ASSESSMENT REPORT

Section 75W Modification

**Orica Southlands Remediation and Warehouse Development Project –
Warehouse Reconfiguration (MP 06_0191 MOD 2)**

Figure 6: Proposed Site Layout

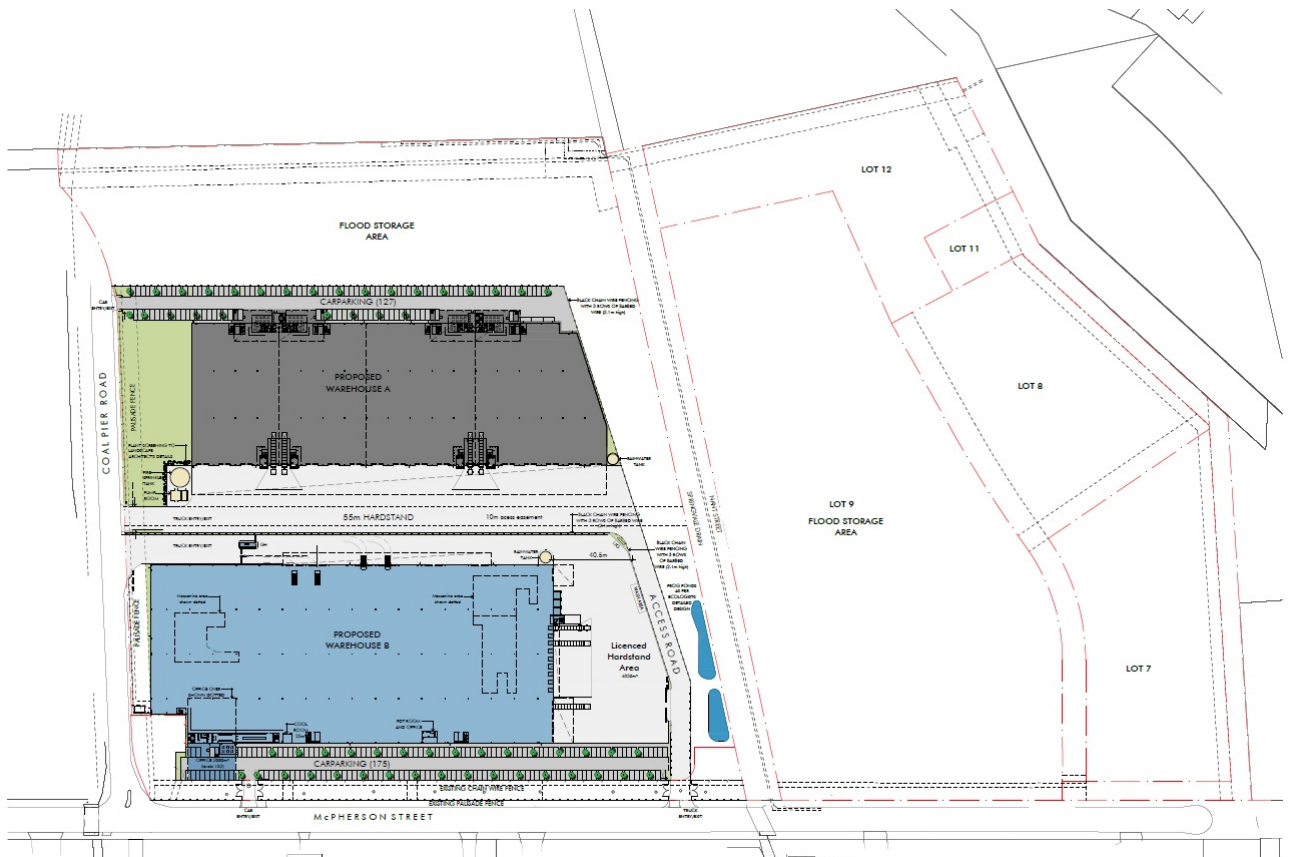
- alteration of the building footprints by consolidating the six approved warehouse buildings into two larger warehouse buildings;
- reduction of lots to seven by amending the subdivision plan to retain the two warehouse buildings, associated access ways and parking under a single lot (Lot 102 DP 1189375);
- integration and relocation of car parking areas to provide two consolidated on-site parking areas serving the two warehouse buildings;
- reconfiguration of internal traffic circulation with truck ingress and egress via Coal Pier Road and McPherson Street. Separate light vehicle access is provided via Coal Pier Road for Warehouse A and McPherson Street for Warehouse B; and
- internal fit out of Warehouse B to accommodate Toll's operations.

The proposed amendments (shown in **Figures 6 and 7**) would decrease the number of lots from 12 to seven, increase the total gross floor area from 36,170 m² to 40,386 m², decrease the number of access points off McPherson Street and decrease the number of parking spaces by 39 from 341 to 302.

Figure 9: Proposed layout

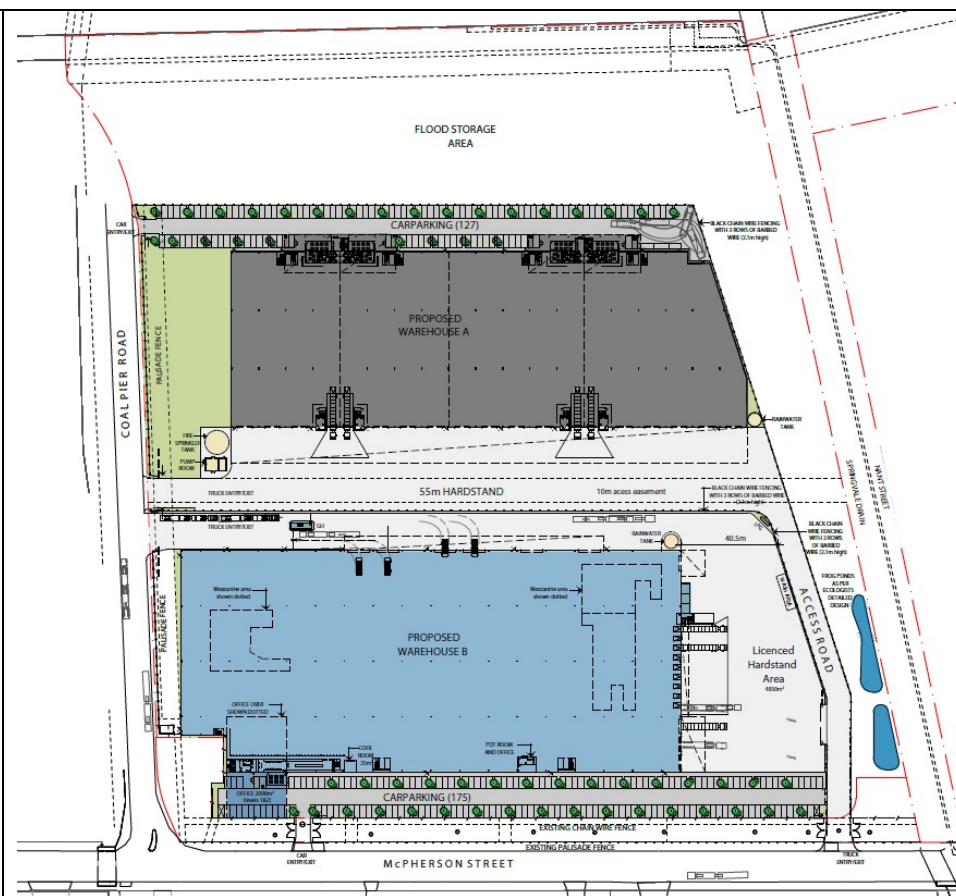
The proposed modification seeks to consolidate the six approved warehouses into two large warehouse buildings oriented east-west, separated by a large area of hardstand providing loading and access areas. See **Figures 8-11** which compare the approved and proposed layout and elevations.

Warehouse A would be 15,100 m² and nominally broken into four smaller units, and Warehouse B would be one building of 22,800 m². The warehouses, although approximately 1 m higher than the buildings originally approved, would remain below height restrictions imposed by the Sydney Airport Corporation Limited (SACL) in relation to airspace protection.

The Department is satisfied that visual impacts would be similar to those approved. However, the Proponent is seeking to remove the existing commitment which requires the submission of the detailed design of each building to Botany Bay City Council for design input from the Council's Urban Design Review Panel.

As per the original approval, the Department is satisfied that visual impacts from the modification would be consistent with the industrial nature of the area. Furthermore, the Project Approval requires a detailed landscape plan to be prepared in consultation with Council. The Department considers that landscaping can help break up the bulk of the building and soften views from public spaces.

Figure 11: Proposed southern elevation, from McPherson Street (additional landscaping in car park not shown)

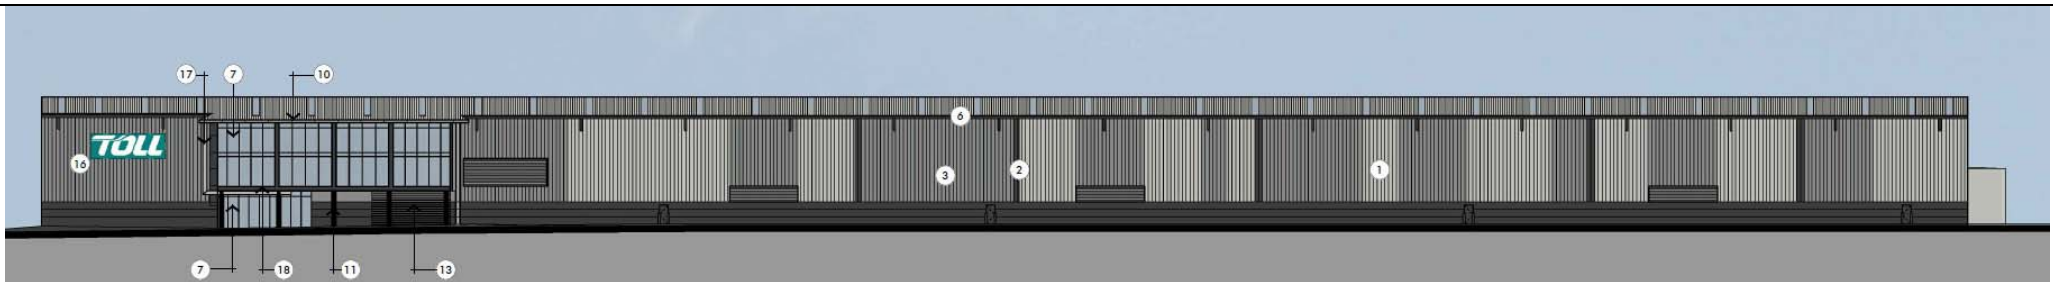
Although the bulk and scale of the warehouses would change, the external finishes would be very similar to those approved, being primarily grey toned colourbond sheeting and a pitched roof. As per the original design, the majority of the hardstand and roller doors are to the rear of the property, away from the street-front.

Council has not objected, however, it sought additional façade treatment and landscaping and recommended a number of detailed conditions. In response the Proponent revised its Landscape Plan to show additional tree planting within the car park area.
